December 12, 2024

Re: Response to Comments  
Permit Modification – Final Contour Plan Improvements  
McCarty Road Landfill – Permit No. MSW-261B  
Harris County, Texas  
Tracking No. 30168338

FIGURE 4.7

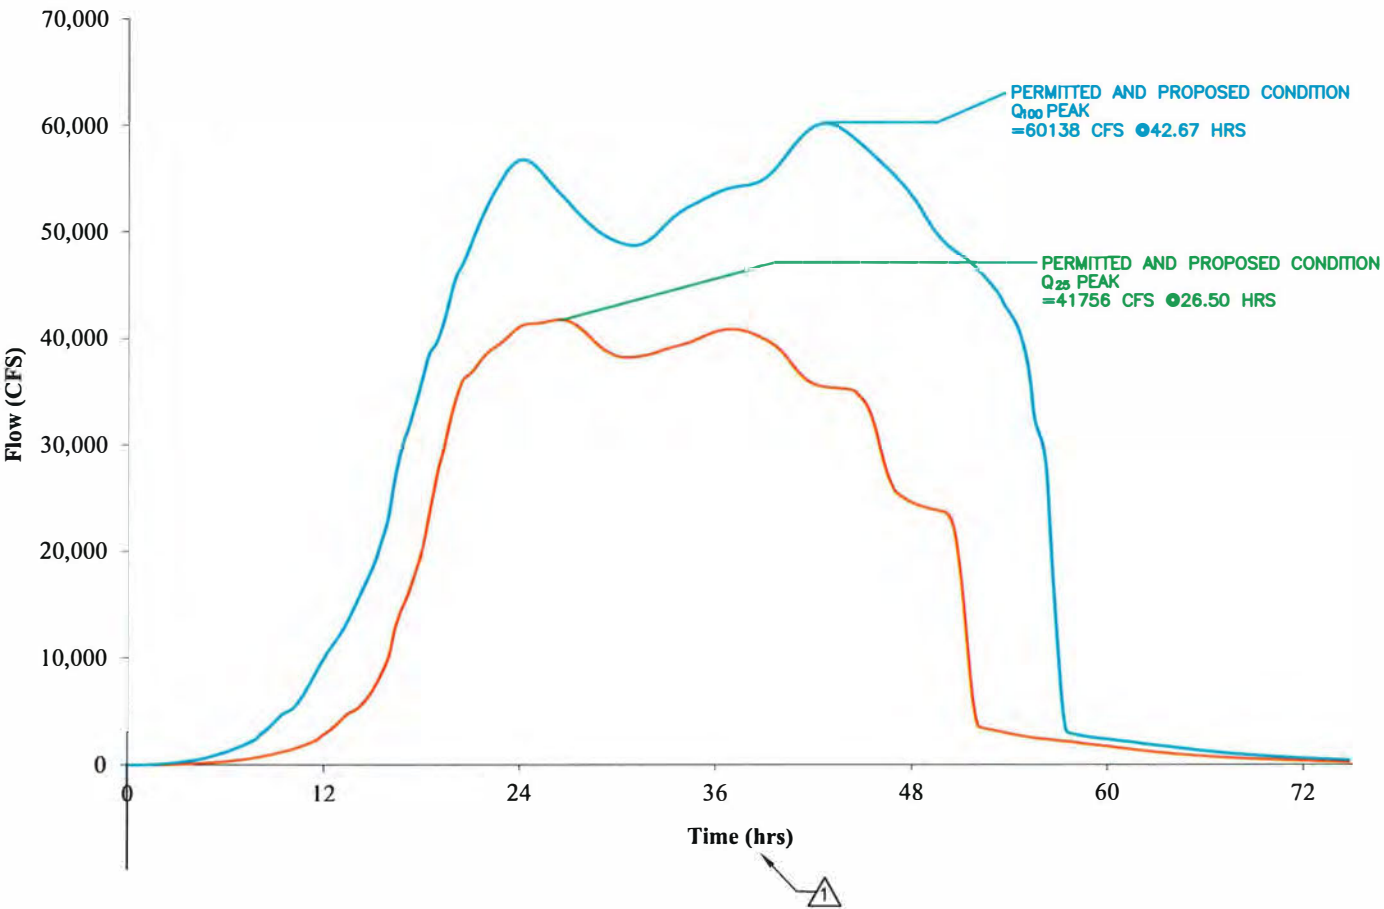
7. **Attachment 6A, Figure 4.7 the curves for the higher flow appear to be mislabeled as Q25 PEAK (colored blue) whereas it should be Q100. Also, the new results of 60,138 and 41,756 cubic feet per second (cfs) are much higher than the Rev. 1, 08/2006 results of 37,768 and 31,186 cfs for Q100 and Q25, respectively. Thirdly, the new figure has a Rev. 1 date of 10/2010. Please make changes where necessary and address each of these instances in the narrative.**

**Response:**
